AUBURN HILLS 11TH ADDITION

WICHITA, SEDGWICK COUNTY, KANSAS

RE: SUB 2000-30 -- Revised Final Plat of Auburn Hills 11th Addition

CASE NUMBER: SUB 2000-30 -- AUBURN HILLS 11TH ADDITION

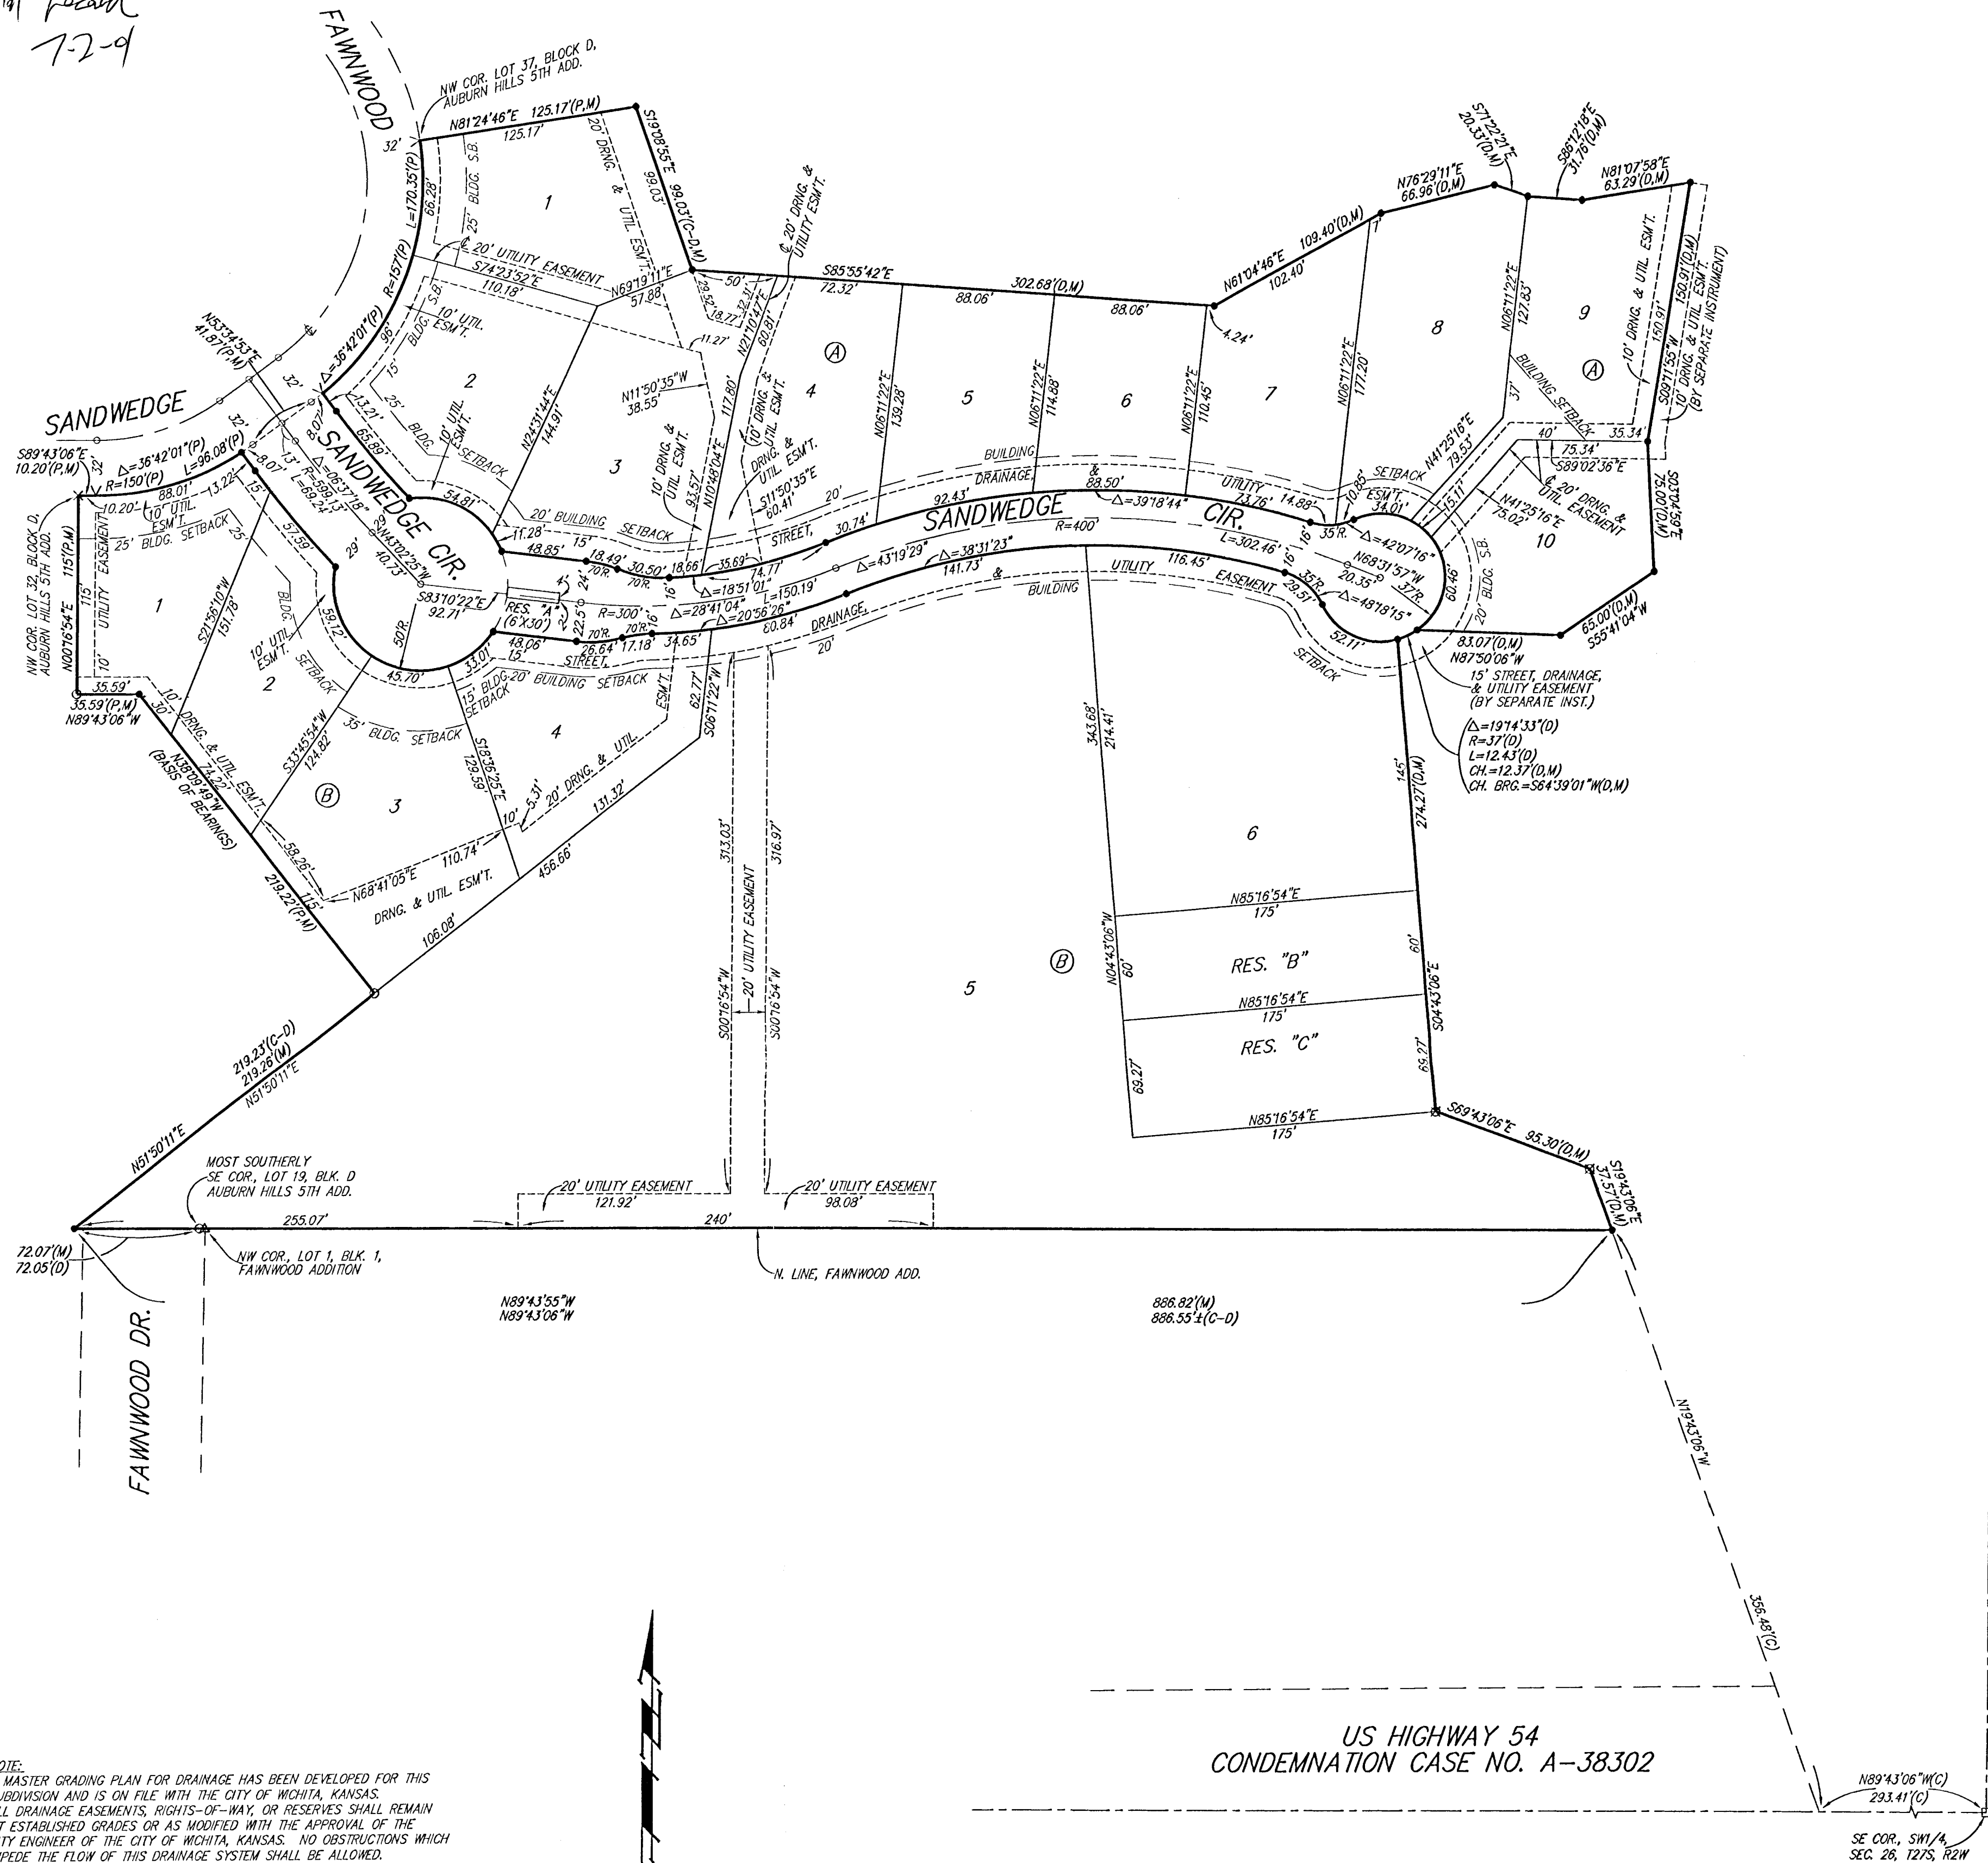
- C. City Engineering needs to comment on the status of the applicant's drainage plan. The drainage plan is approved. An off-site drainage easement and cross-lot drainage easement are required.

- F. The township needs to be added to the surveyor's certification.

- G. Lot 2, Block 2 does not conform with the 50 foot lot width requirement at the front property line. A building setback should be platted at a minimum of 50 feet measured from the side lot lines. City Fire Department has required a fire hydrant placed at the front of this lot. The building setback has been platted as requested.

- H. The applicant shall guarantee the paving of the proposed interior streets.
- I. The 10-ft easement dimension on Lot 3, Block B, needs corrected.
- J. City Fire Department should comment on the length of Sandwedge Circle (700 ft) which exceeds the 600 ft maximum for a cul-de-sac. City Fire has approved this street length with the addition of a second point of access. In the event the second point of access does not occur through Fawnwood, the northern segment of Fawnwood abutting this plat should be vacated.

- K. Block B shall be revised to "Block 1".
- L. Based upon the platting binder, property taxes are still outstanding. Before the plat is scheduled for City Council consideration, proof shall be provided indicating that all applicable property taxes have been paid.

- M. Since this plat proposes the platting of narrow street right-of-way with adjacent 15-foot street, drainage and utility easements, a restrictive covenant shall be submitted which calls out restrictions for lot owner use of these easements. Retaining walls and change of grade shall be prohibited within these easements as well as fences, earth berms and mass plantings.

- O. The platlor's text shall include language that a drainage plan has been developed for the plat and that all drainage easements, rights-of-way, or reserves shall remain at established grades or as modified with the approval of the applicable City or County Engineer, and unobstructed to allow for the conveyance of stormwater.

- W. The representatives from the utility companies should be prepared to comment on the need for any additional utility easements to be platted on this property. KGE has requested additional utility easements.
